# CHANGE ORDER

"B"

PROJECT:  
**LEXINGTON ESTATES**  
93 LEXINGTON DRIVE  
DUNEDIN, FLORIDA

## ENTRANCE GATE PLAN

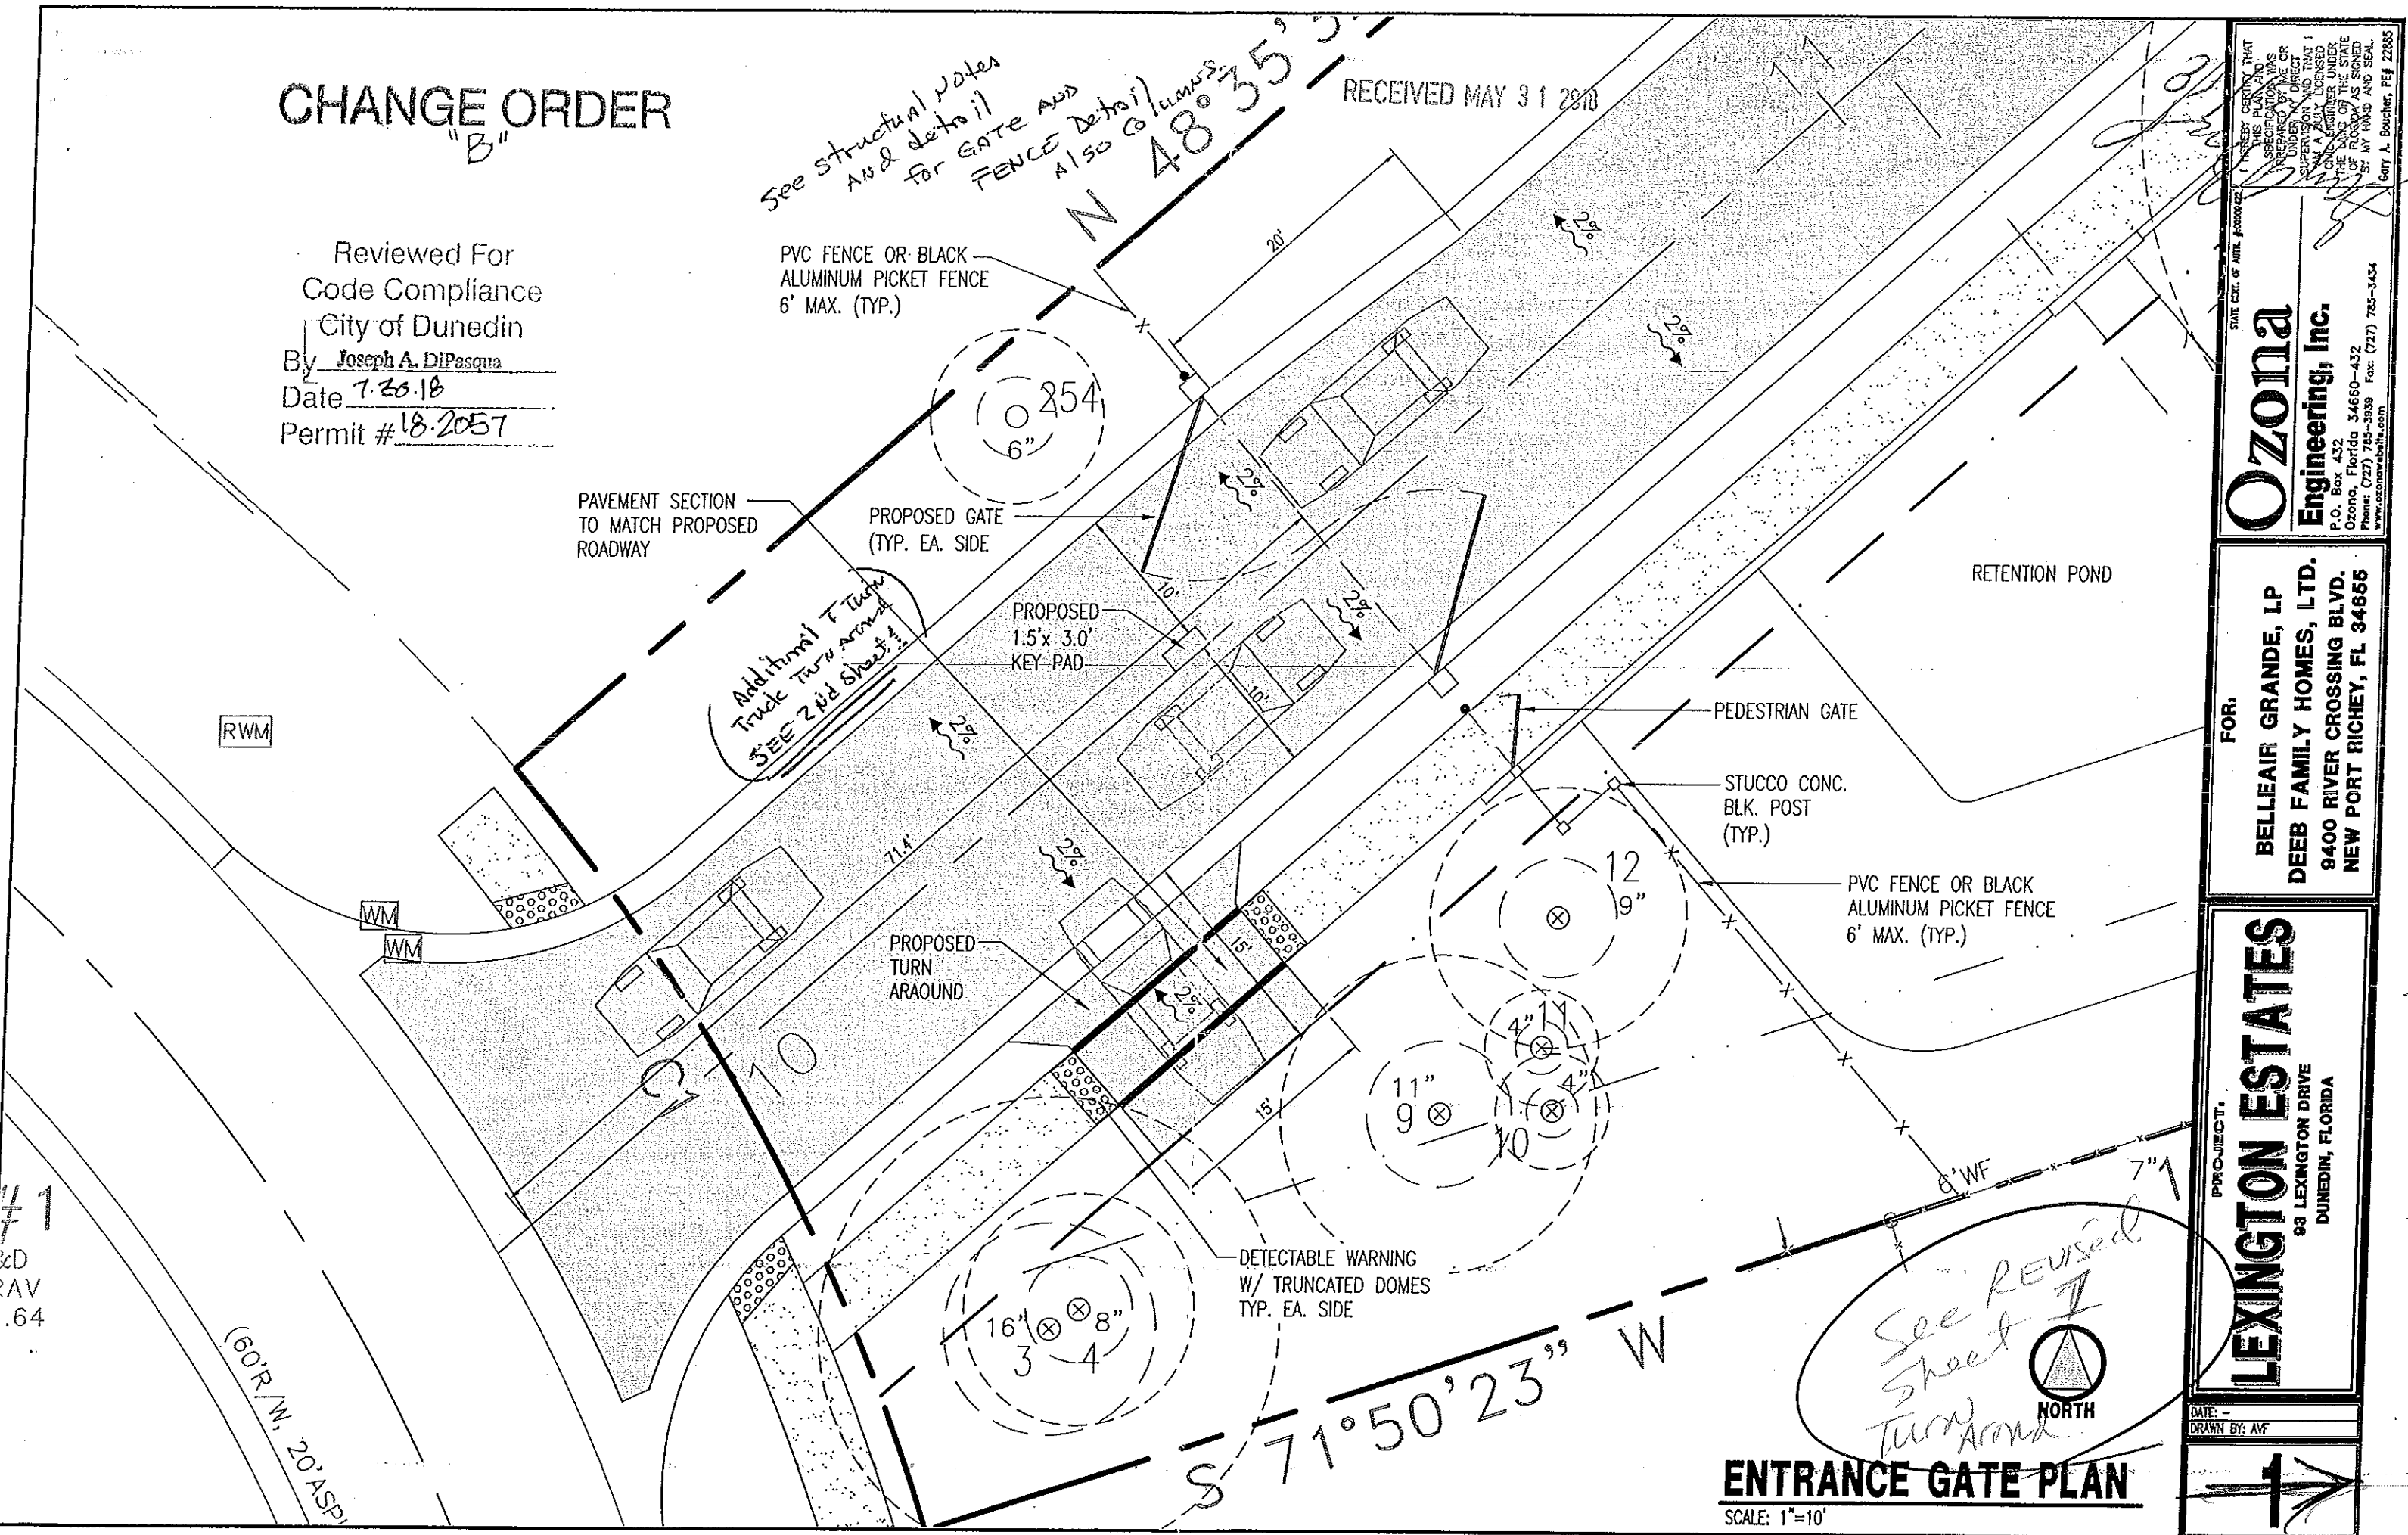
*See structural notes  
and detail  
for GATE AND  
FENCE Detail  
Also G/CUMMINS*

*Additional T Turn  
Truck Turn Around  
SEE 2nd Sheet*

*See Revised  
Sheet 7  
Turn Around*

## ENTRANCE GATE PLAN

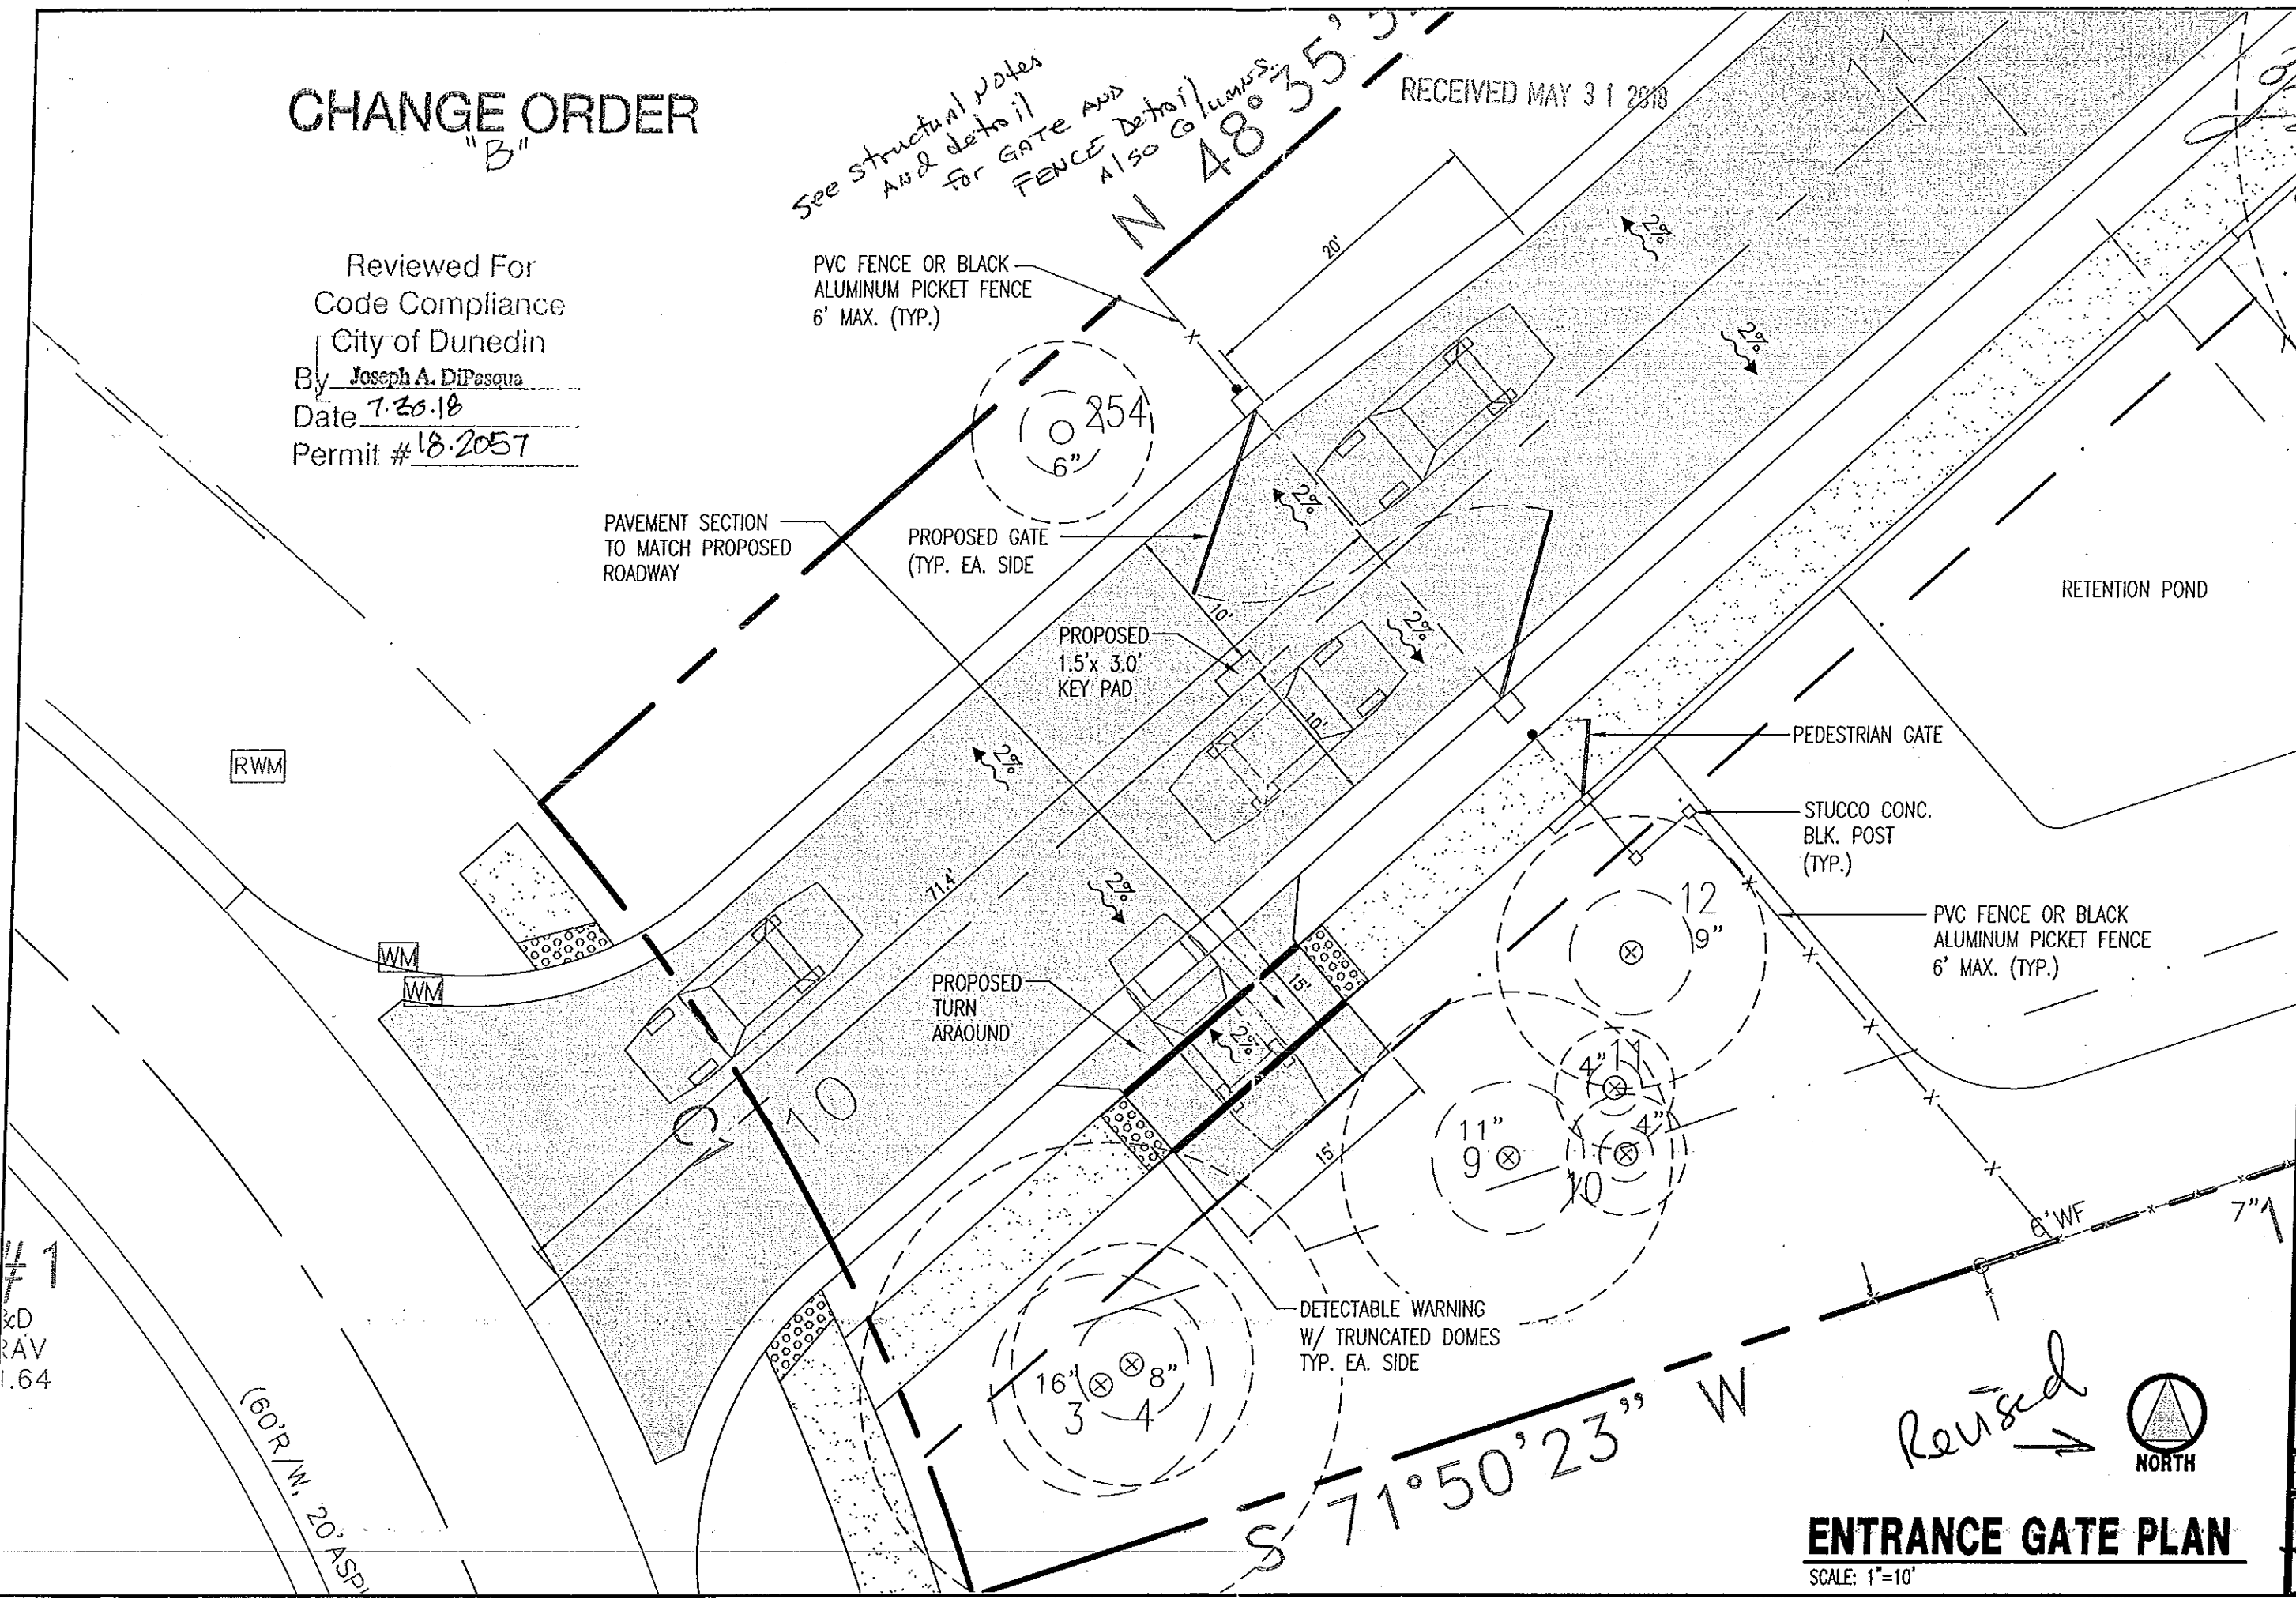
See structural notes  
and detail  
for GATE AND  
FENCE Detail  
Also columns

Revised →

ALL PERMITTED FENCES SHALL BE LOCATED  
ON THE PROPERTY OF THE APPLICANT  
AND NOT WITHIN ANY PUBLIC RIGHT-OF-WAY.

PROPOSED 1.5'x 3.0'  
KEY PAD W/KNOX BOX  
KEY ACCESS CONTROL

GATES SHALL NOT SWING  
OUTSIDE PROPERTY LINES  
PAVEMENT SECTION  
TO MATCH PROPOSED  
ROADWAY

FINISHED SIDE OF FENCE MUST FACE  
ABUTTING PROPERTIES. ALL SUPPORT  
MEMBERS MUST BE INSIDE OF FENCE.

OBSTRUCTIONS (FENCES, SHRUBS, ETC) WITHIN  
EASEMENTS ARE SUBJECT TO REMOVAL AT NO  
COST OR OBLIGATION TO THE CITY OF DUNEDIN.

NO SHARP POINTS ALLOWED.
